Engine Mount Fatigue Cracks

EFFECTIVITY**MODEL-** Ranger R7**SERIAL NO:** ALL AIRCRAFT WITH SERIAL NUMBER LESS THAN 10203**REASON**

Fatigue cracks have been reported on the engine mount lug welds caused by insufficient weld fillets. This issue has been traced back to batch of aircraft with serial number identified above.

Appendix A: Inspection Of Engine Mount

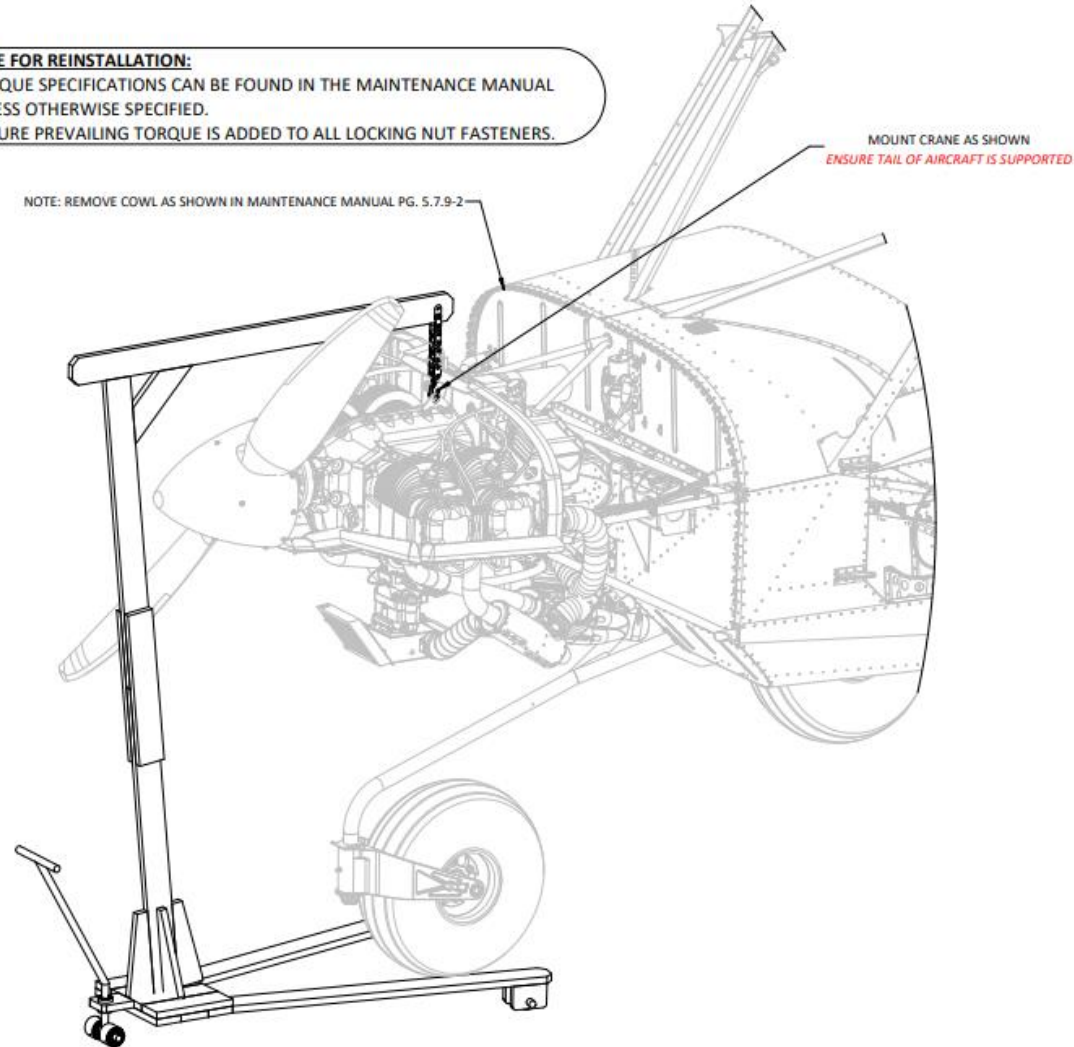
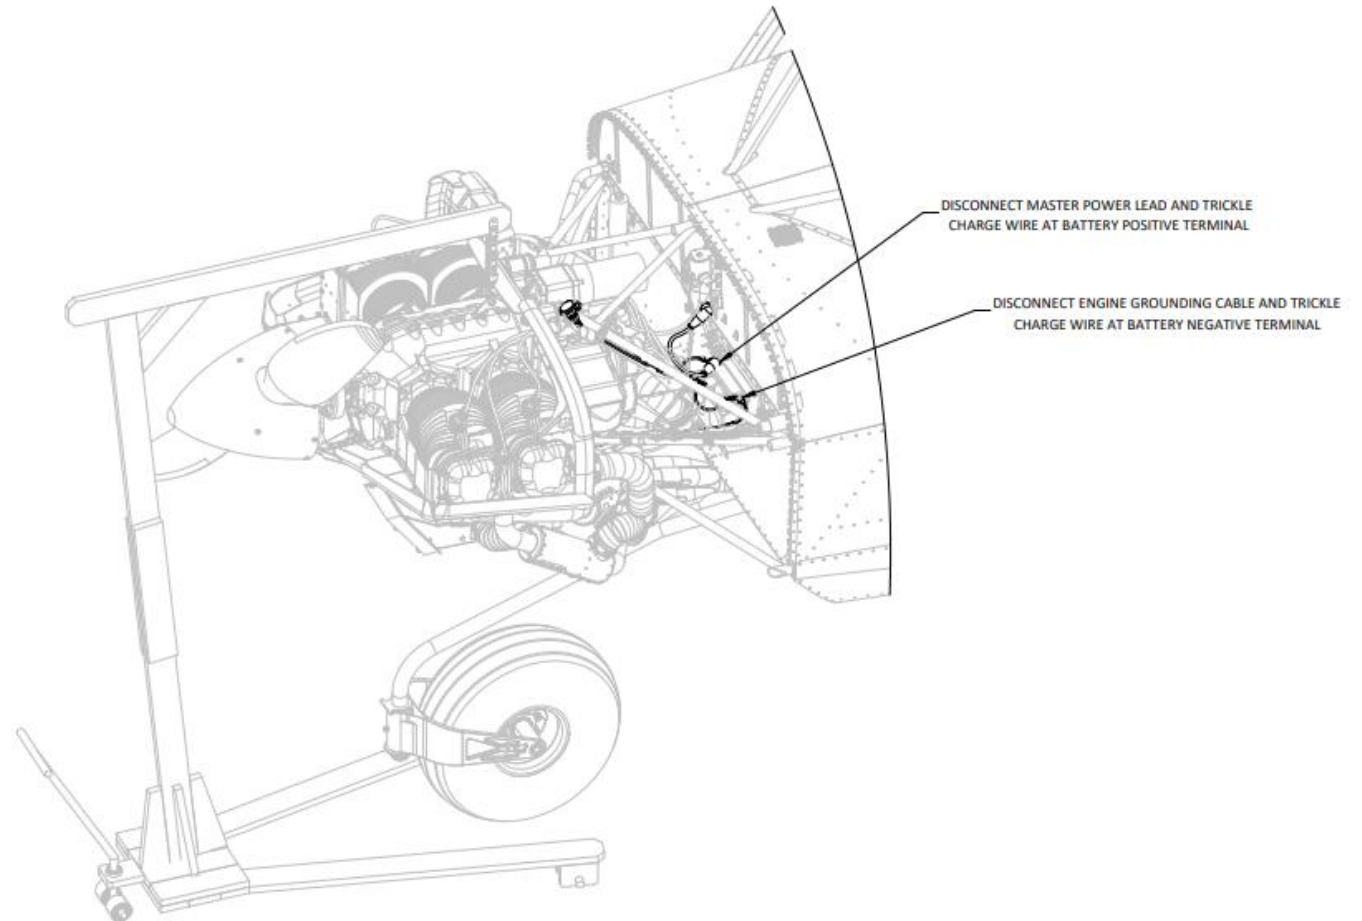
Inspect the engine mounting weldment for cracks.

Inspect weldment as shown in Appendix A. If any cracks are present, DO NOT continue to fly – Contact Vashon Aircraft Support for corrective action.

DETAIL C

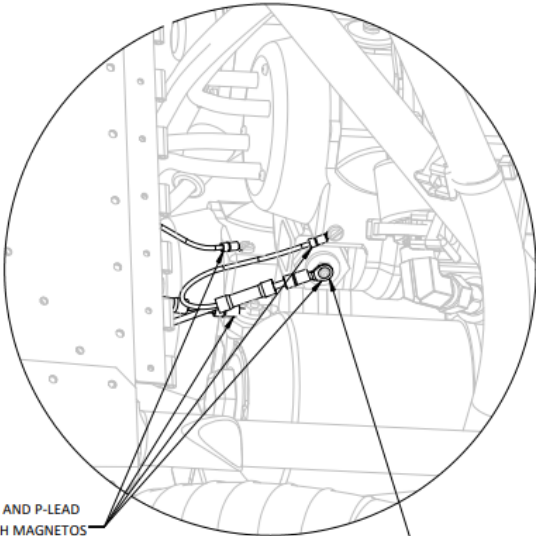
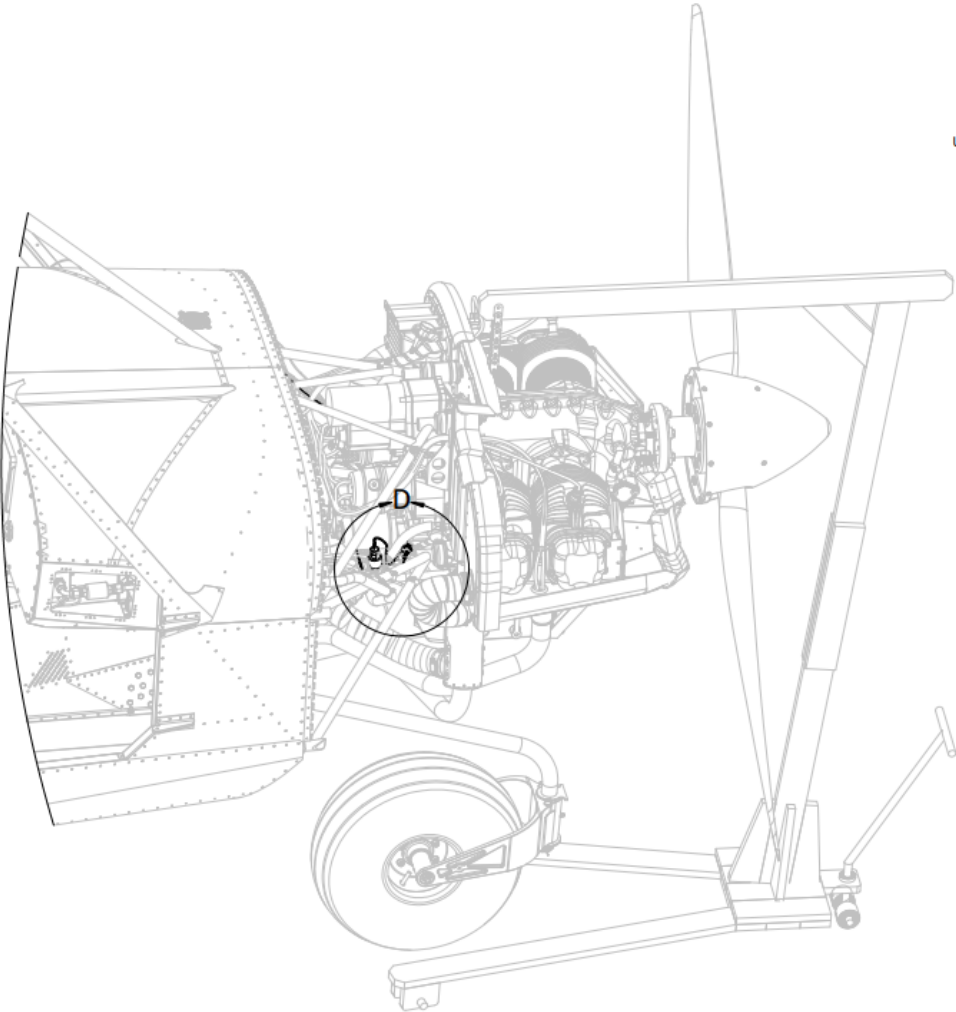
DISCONNECT GROUND AND P-LEAD
CONNECTIONS ON BOTH MAGNETOS

P-LEAD MAX TORQUE
OF 15 IN-LBS

DETAIL D

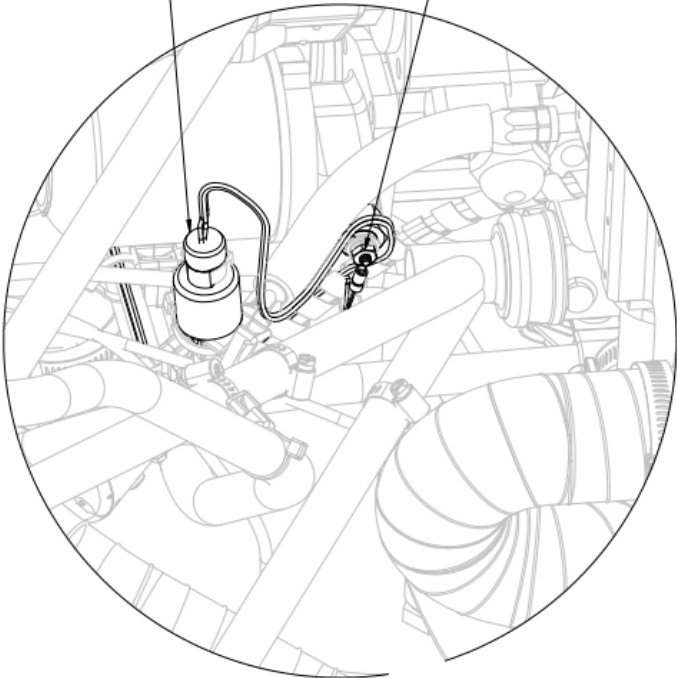
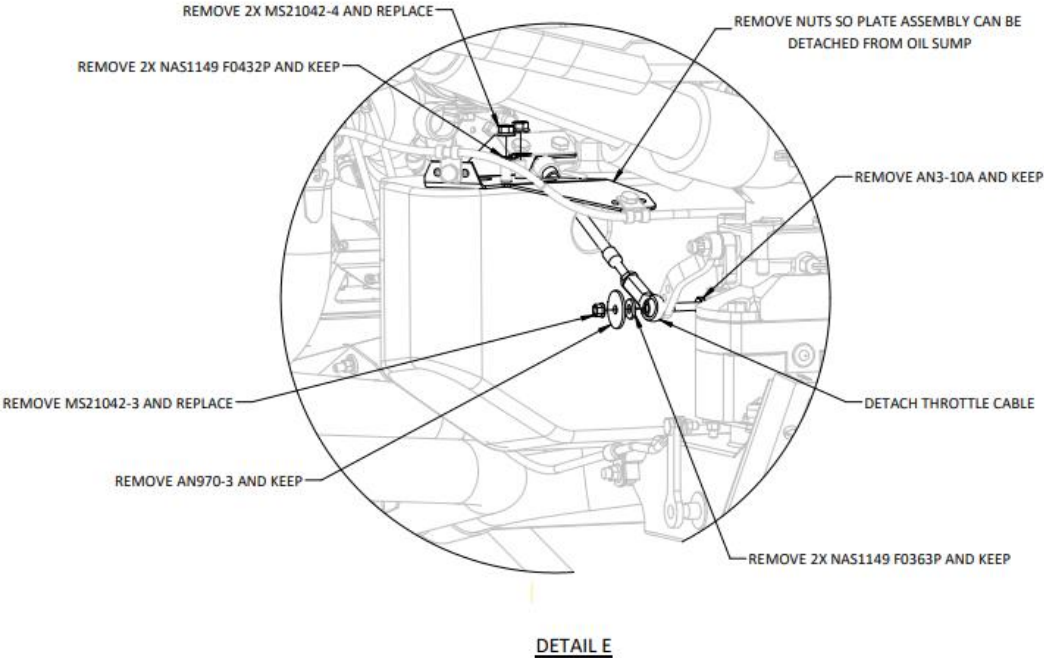
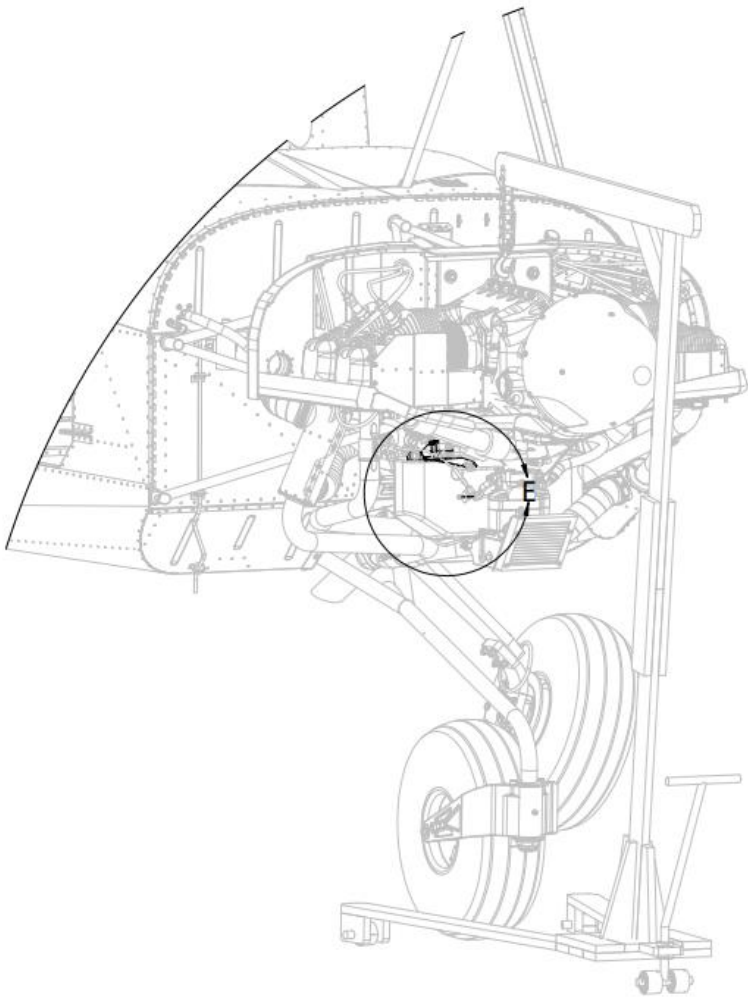
UNPLUG OIL PRESSURE SENSOR AT CONNECTOR

DISCONNECT OIL TEMPERATURE SENSOR AT TERMINAL

DETAIL F

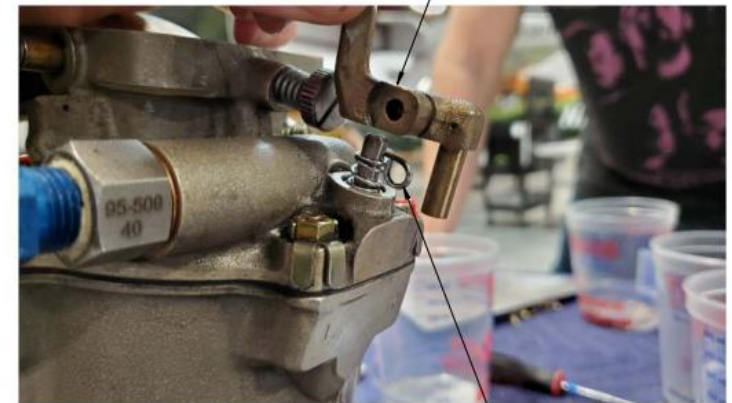
REMOVE SCREW AND KEEP.
(NOTE: ARM WILL POP UP WHEN SCREW IS REMOVED)

REMOVE CONTROL ARM STILL
ATTACHED TO MIXTURE CABLE

NOTE: DO NOT LOSE SPRING AND KEY

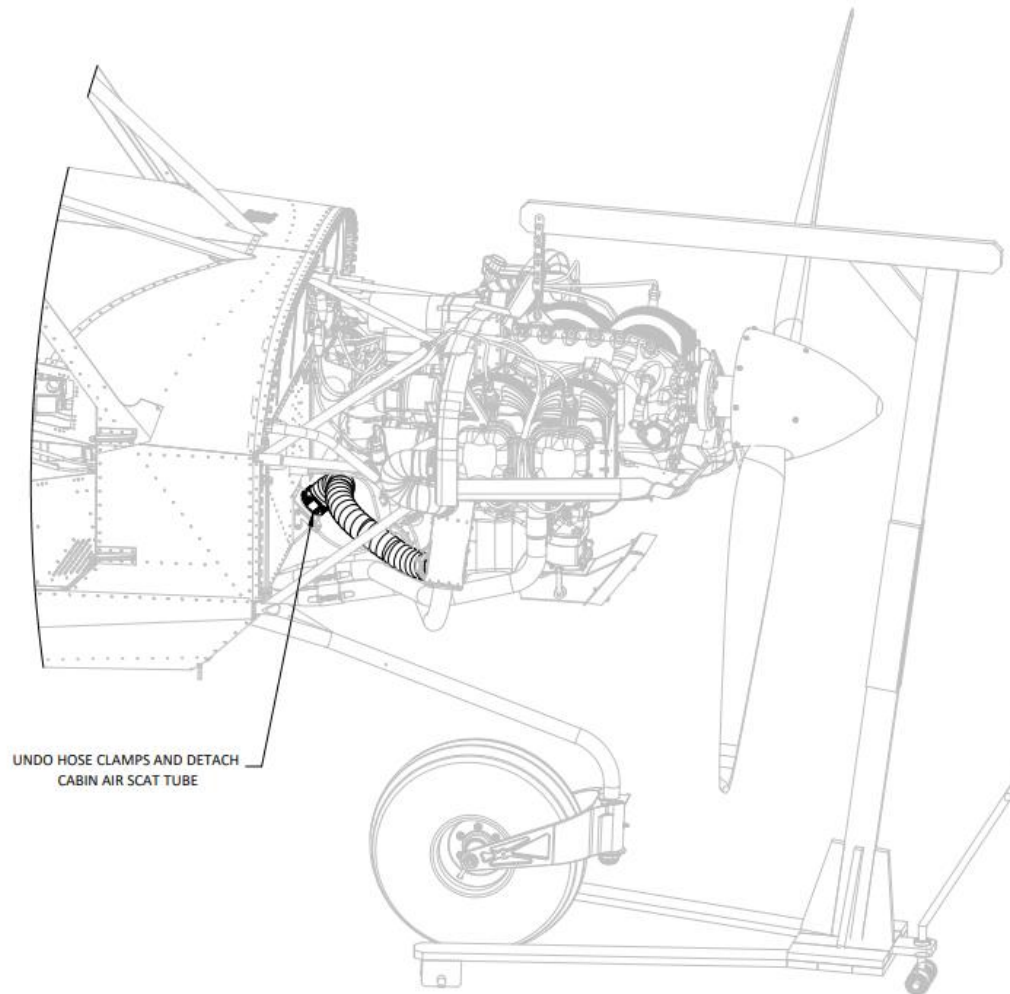
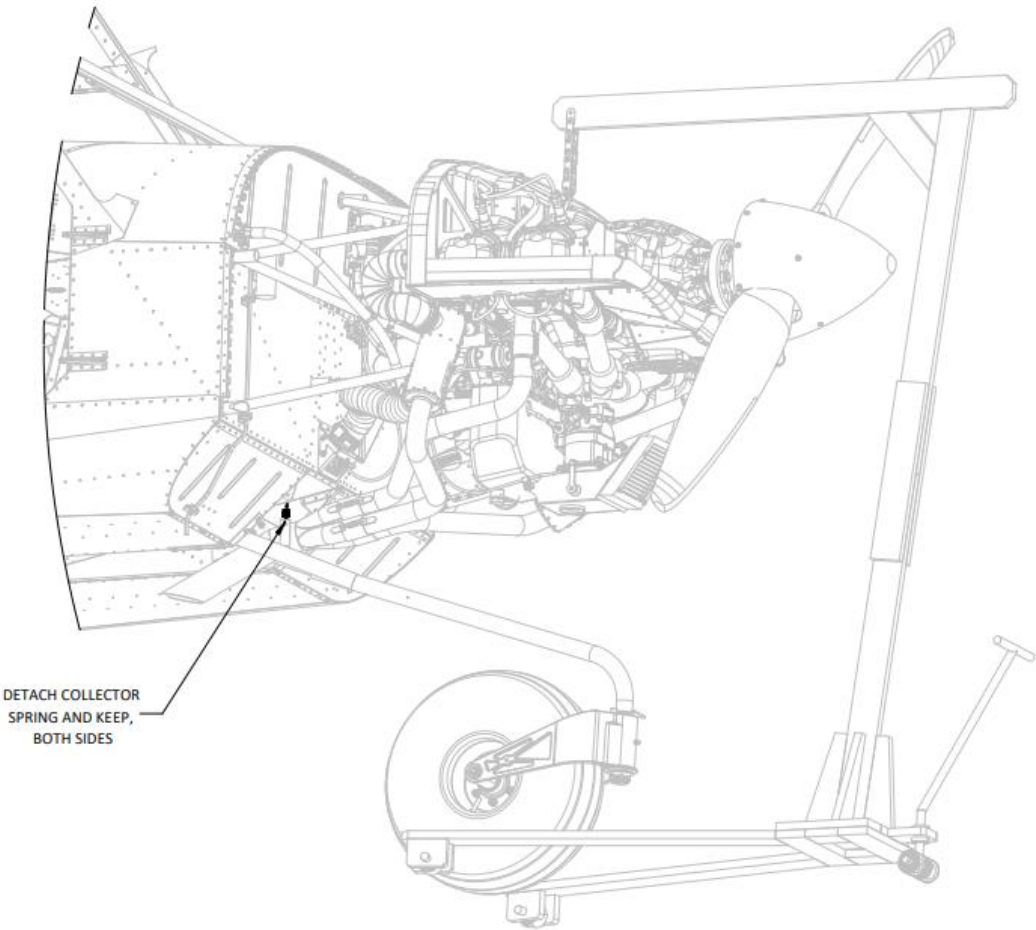
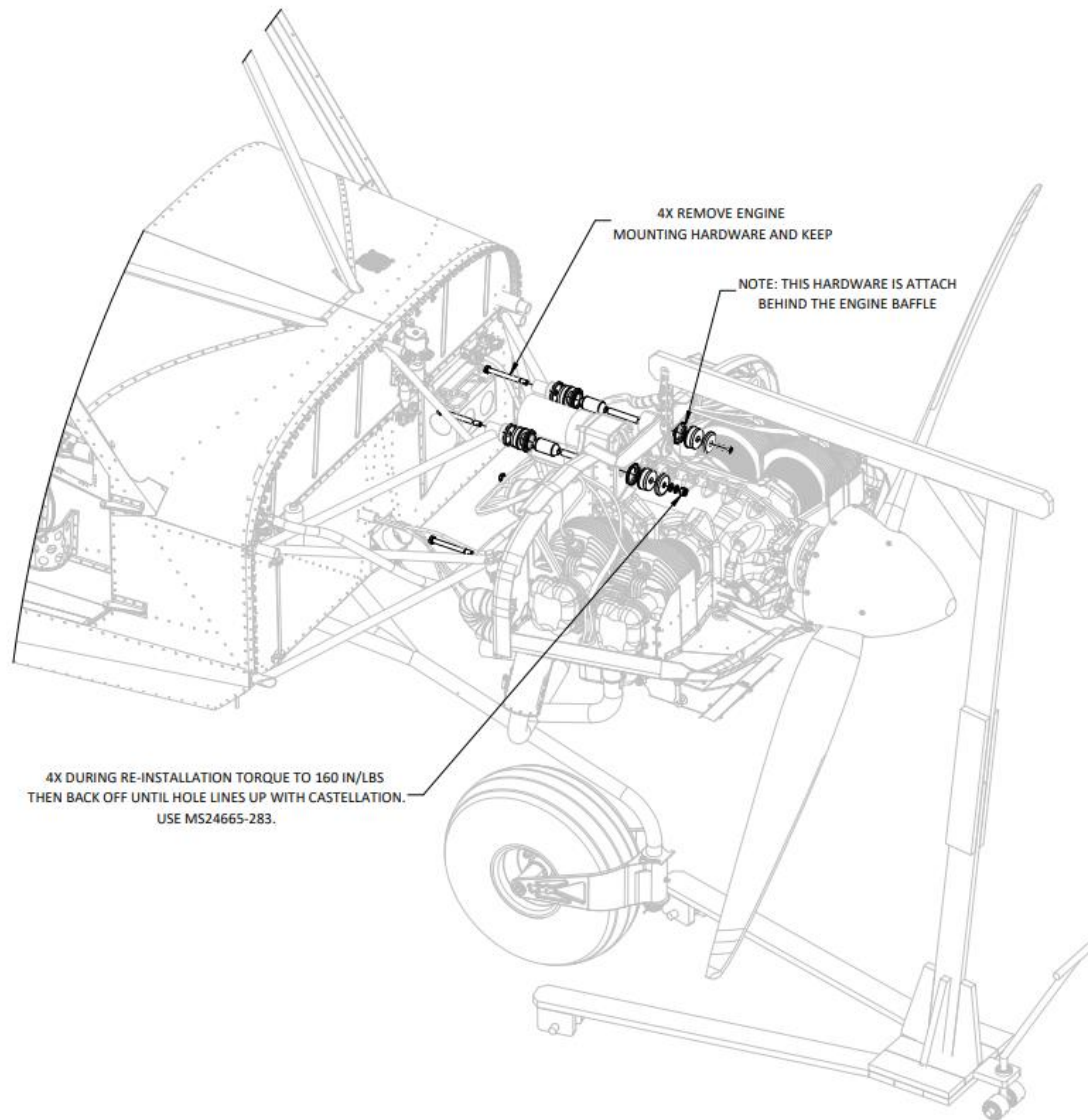
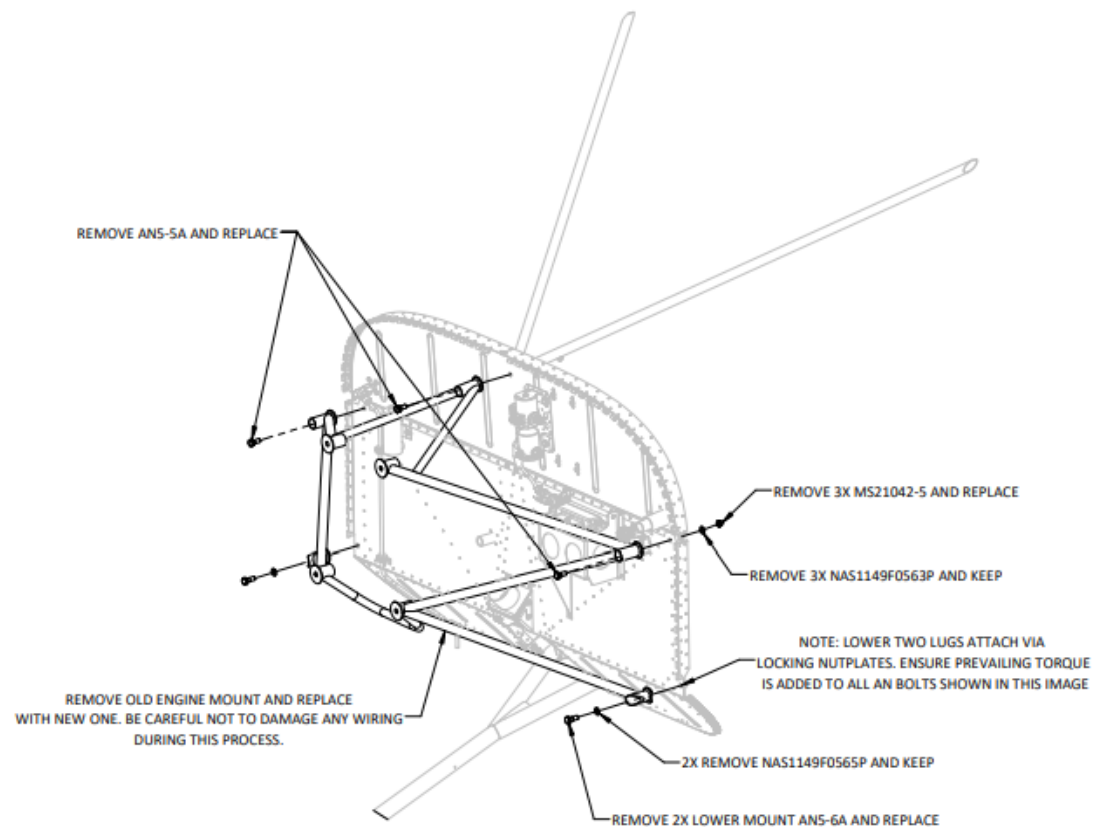
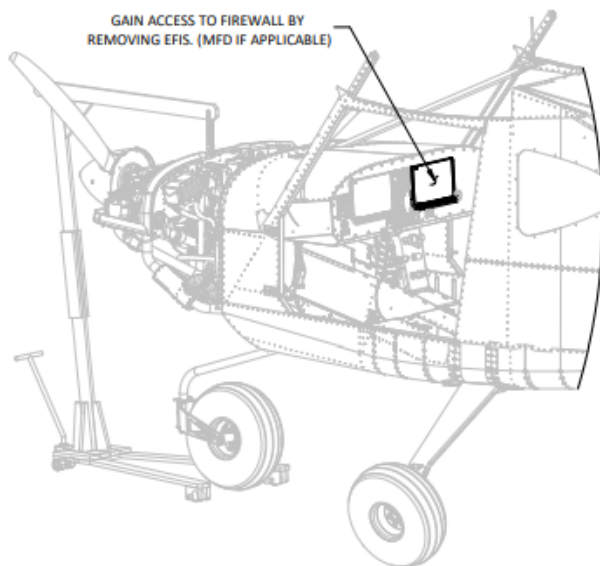
DURING REINSTALLATION; REPLACE AND CLAMP WASHER FLANGES.
MCFARLANE PART NUMBER 78-A109

NOTE: ENGINE WILL STILL BE CONNECTED WITH CABLING AND IS NOT SHOWN IN IMAGE
